Introduction about connector changed of SunESS HV stacked product

SunESS-H/SunESS Power All in One

② Pre-change vs. Post-change (Example: battery pack)

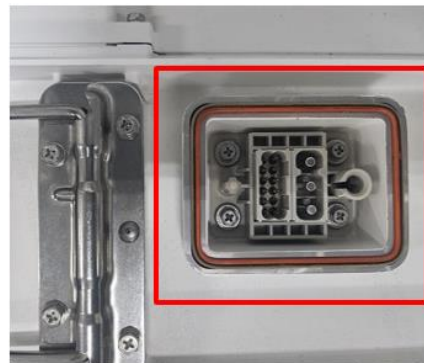
① Connector

Pre-change (Connector A)

Post-change (Connector B)

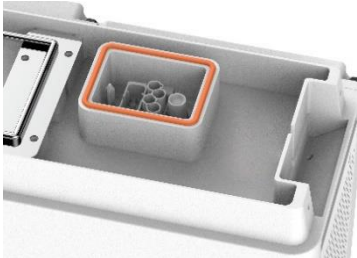
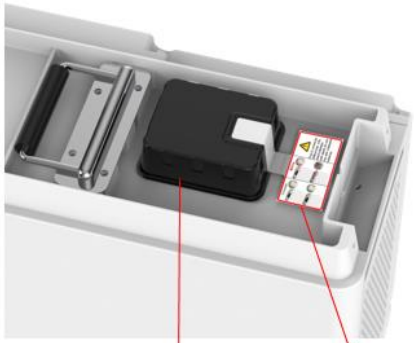
The products with different connectors (A and B) **cannot be stacked and mixed with each other**. Mixed use cause connector damage. Please follow the instructions below to distinguish and correct installation.

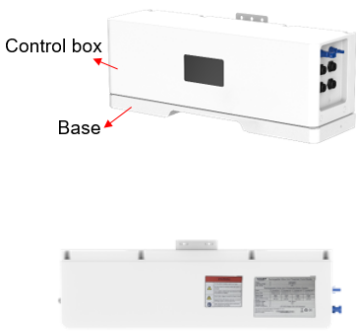
① Distinguish the color of packaging carton (Battery module/ Control module /Inverter module) **Pre-change vs. Post-change**

Pre-change packaging carton	Post-change packaging carton
Battery module 	
Control module+Base 	
Inverter module+Base

② Distinguish the labels on battery shell. (Remove the packaging carton)

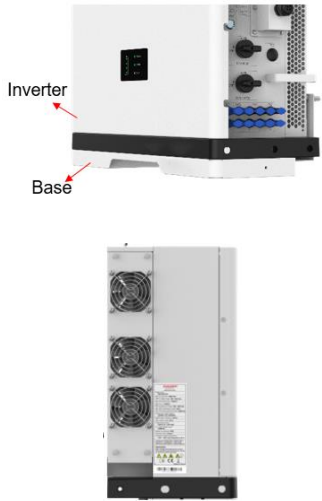
Pre-change Battery module shell	Post-change Battery module shell
	  blister cover  warning label Blister cover: Remove blister cover and separate from warning label prior to installation. Warning label: Content: Due to connector differences, only stack batteries with labels. Do not mix with unlabeled batteries.

④ Distinguish the labels on Inverter module shell. (Remove the packaging carton)

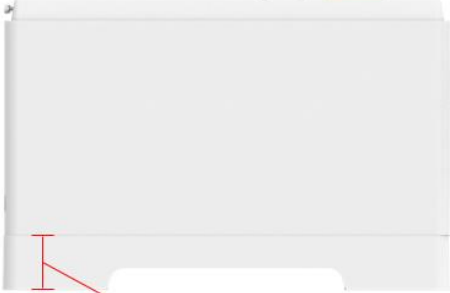
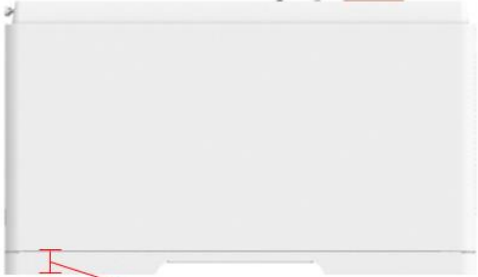
Pre-change Inverter module shell	Post-change Inverter module shell
	 Warning label①: This label is detachable when installed. Content: Due to connector differences, only stack batteries with labels. Do not mix with unlabeled batteries. Warning label②: This label is fixed paste. Content: Due to connector differences, only stack batteries with labels. Do not mix with unlabeled batteries.

Please stack and install the labeled products,
Do not stack labeled and unlabeled products together.
Unlabeled products can only stack with unlabeled ones.
Please contact our professional technician to confirm the connector version before replacing the battery pack, do not operate privately.
